July 10, 2005
JAFP-05-0106

**SUBJECT: James A. FitzPatrick Nuclear Power Plant
Docket No. 50-333
Request for Additional Information on Relief Request No. RR-38,
Proposed Alternative to Perform a Temporary Non-Code Repair in
accordance with 10 CFR 50.55a(a)(3)(ii)**

**Additional Information on Relief Request No. RR-38
Non-Code and Code Repair Discussion**

**Additional Information on Relief Request No. RR-38
Temporary Support for RHR SDC Line**

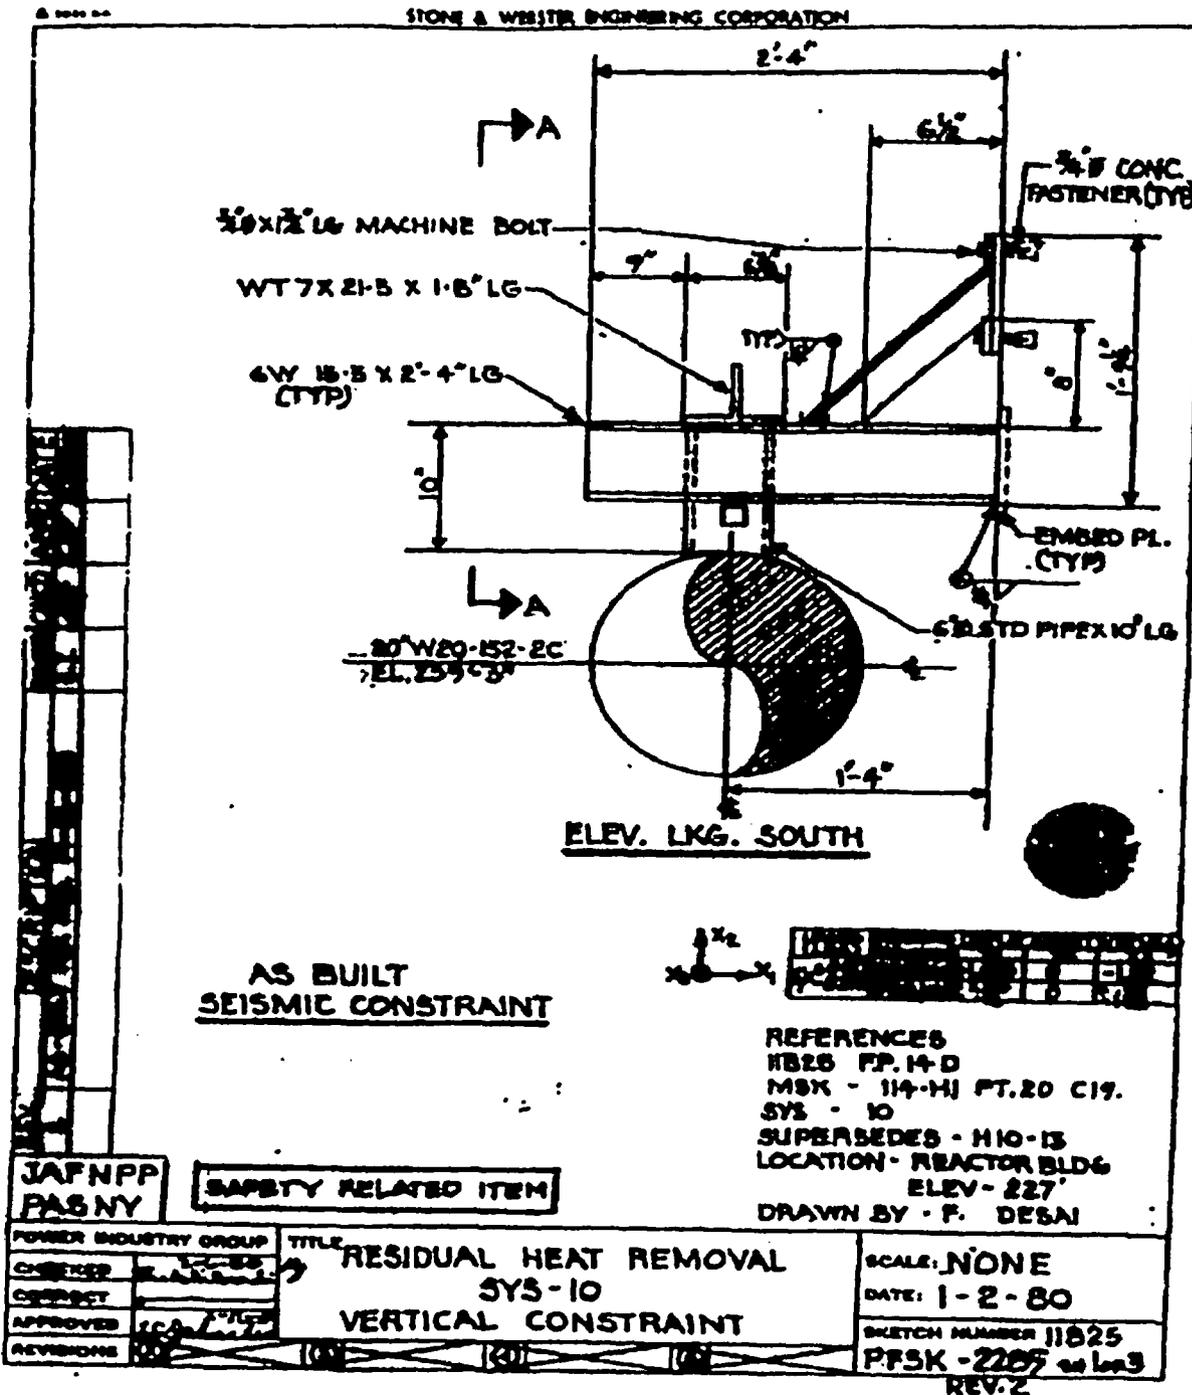
The subject piping through-wall crack is a 6.5" linear crack in the 20" RHR SDC pipe, which follows the toe of the pipe support trunnion-to-pipe fillet weld. This integral attachment weld is a 3/8" fillet weld, continuous around the 6" (6.625" OD) pipe trunnion for a total length of 21" with the crack comprising about 31% of the total length. The crack extent was determined based on a VT-1 ISI Visual exam (100% of the weld), and confirmed by a "Fluorescent Wet-Mag" Surface exam for about 60% of the weld based on accessibility. The remaining third of the weld (back side of the trunnion) opposite of the crack was verified to have no indications based on a PT Surface exam.

Pipe line number 10-20"-W20-152-2C is the common header of the RHR SDC suction piping located in the Crescents. This portion of the system is ISI Class 2, with applicable Power Piping Code USAS (ANSI) B31.1 (1967 ed. through 1969 addenda). The piping and supports are designed for normal operating load conditions (pressure, deadweight, thermal), as well as Operating and Design Basis Earthquake loading. In addition, the designs include torus-attached piping dynamic load conditions. The piping is carbon steel, standard wall (0.375" thick), and a system pressure of 50 PSIG (operating) and 150 PSIG (design) at a temperature of 90-280 (degf).

The subject degraded pipe support (PFSK-2285) is designed as a two-way vertical support, primarily for a downward dead load, but also for plus and minus vertical dynamic loads (seismic and torus-attached piping loads) as well as a small downward thermal load. The support configuration is designed as a lateral sliding support such that the pipe is not restrained in any of the lateral directions (except for minor lateral loading on the support due to friction). Less than two feet away is another permanent rigid support (PFSK-2084), which assists primarily in carrying downward loads, but no dynamic upwards load. The piping displacements are negligible due to the line being supported and restrained in all directions for dynamic load conditions (seismic and torus loads). The only operating conditions that are not specifically analyzed for is fluid transients and normal piping vibration, which are outside the design requirements. Fluid transients (such as water hammer) would not be expected to cause a significant challenge to this degraded pipe and support due to the lateral and axial dynamic restraints on the piping (anchor, snubbers, and struts). The normal piping vibration was attributed as the primary factor in the apparent high cycle fatigue failure at the trunnion-to pipe attachment (Ref. Root Cause Analysis Report for CR-JAF-2005-02749). This piping vibration has been significantly dampened out at the subject PFSK-2285 trunnion location by the addition of a shim plate under the bearing plate at support PFSK-2084 immediately after the pipe leak was discovered.

Additional Information on Relief Request No. RR-38
 Temporary Support for RHR SDC 1 line

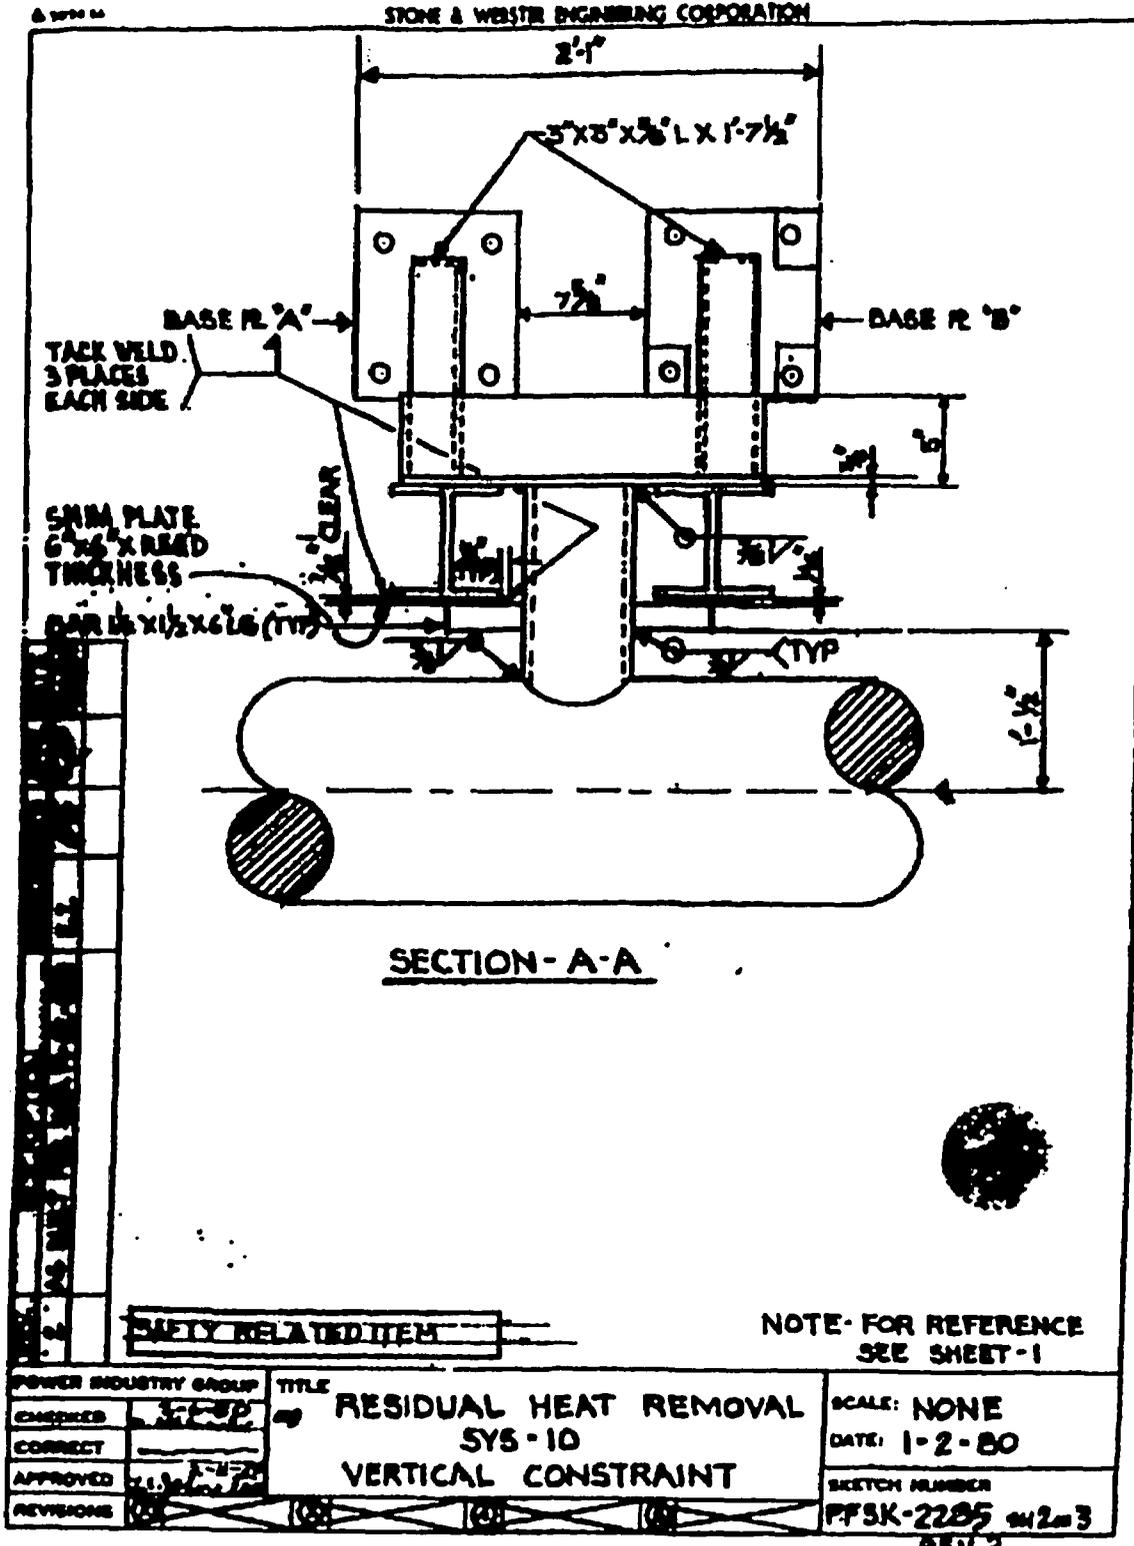
- The pipe crack will be stressed-relieved locally by applicable technique recognized within fracture mechanics (commonly referred to as “crack arrest”), which involves drilling approximately 1/8” diameter hole through the pipe at each end of the crack. This effectively prevents the crack propagation mechanism by eliminating the stress riser at the tips of the crack.

- The primary cause of the failure was high cycle fatigue due to vibration. The condition developed during shutdown cooling mode of operation cumulative over the 30 year life of the plant. The localized vibration at this failed trunnion support has been significantly reduced by restoring the adjacent support (PFSK-2084) by installing a shim plate where the support was not load-bearing as intended. The reduced vibration at the failed trunnion support during shutdown cooling mode is no longer a significant concern for the relatively short term that this degraded condition will remain in effect.

- The primary design load at the degraded PFSK-2284 support is dead load (4525# compared to either dynamic load case (+/-1097# seismic, or +/-2610# Torus loading). The bearing shim plate installed at existing adjacent support PFSK-2084 (only 2 feet away) will enable the that support to assist in carrying the dead load. As an extra measure, a suitable temporary deadweight support is positioned under the pipe only a few feet down the pipe on the opposite side of the failed trunnion from PFSK-2084. Thereby two rigid dead load supports, straddling the degraded pipe support PFSK-2285 in close proximity provides a significant level of redundancy for the primary loading, and significantly reduces the downward load on the PFSK-2285 trunnion (for the DL+THER+SEIS+Torus loads all acting downward).

- A conservative evaluation has been performed to demonstrate that the fillet weld attachment between the trunnion and pipe for PFSK-2285 could be reduced 50% in length, and still provide adequate load capacity for the design conditions.

- The temporary seal welded patch over the pipe crack is intended to prevent further leakage. The through-wall crack is a localized condition, which does not affect the structural integrity of the piping and supports.
